Convention on Nuclear Safety

3rd Review Meeting

Answers (from HSK and RD-BFE) to

Questions on the Swiss National Report in Country Group 5
from the following countries:

Figure: The chronological trend of maximum annual doses per facility separated for plant own personnel and for external personnel.

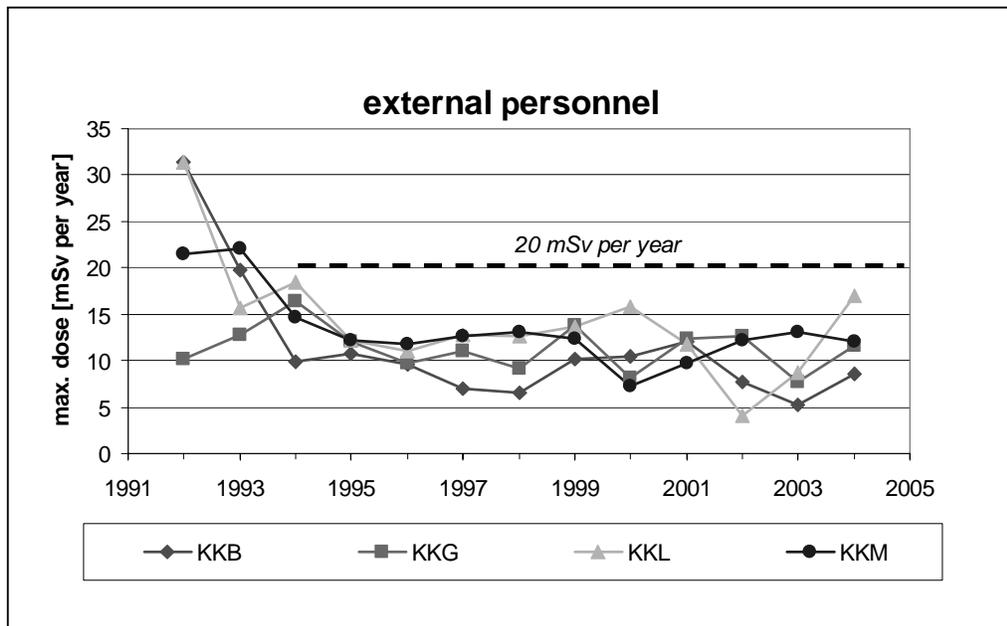
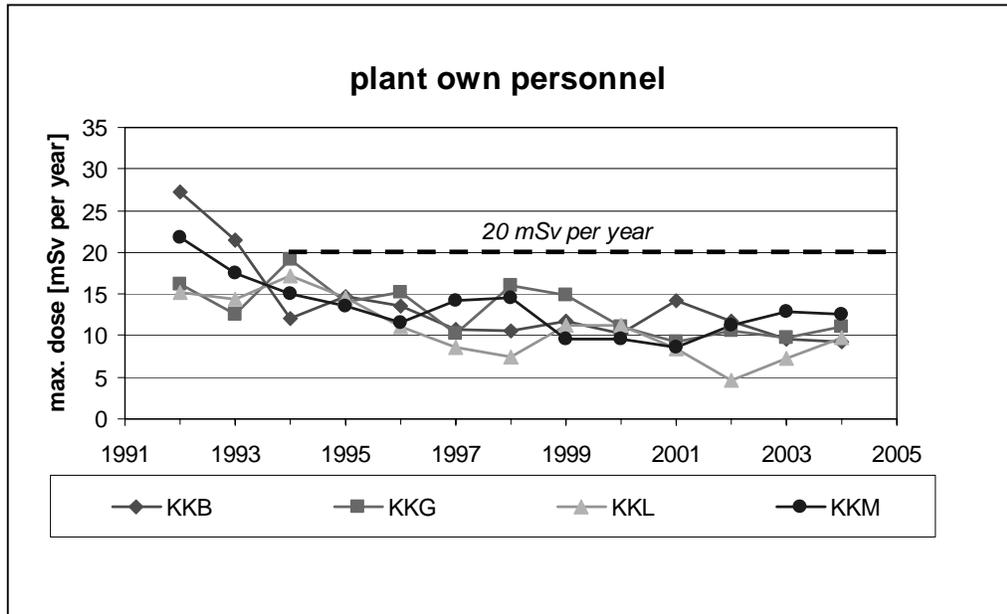
Seq. No 73	Article 15	Ref. in National Report: p. 51
Question/ Comment	The report mentions the average dose received by the plant personnel and contractors (p. 51 and Figure 5 p. 52) and shows their decreasing trend with the year. However there is no figure about the maximum dose received by a worker, which is an other indicator useful to check that radiation exposure is kept to the minimum. Could Switzerland provide some indication about these maximum doses during the review period?

Answer	The highest maximum annual individual dose of the last ten years received in Swiss nuclear facilities was 17.0 mSv per year (2004 NPP Leibstadt). The reason for this value was a lot of work on fittings with high dose rates in the shutdown phase in 2004, which could only be done by a small number of specialists. There was nobody, whose annual dose exceeded the individual dose limit of 20 mSv per year for occupational exposure since 1994, when the Radiological Protection Ordinance came into force. The figure, which you find in the Appendix to the answer shows the chronological trend of maximum annual doses per facility separated for plant own personnel and for external personnel.
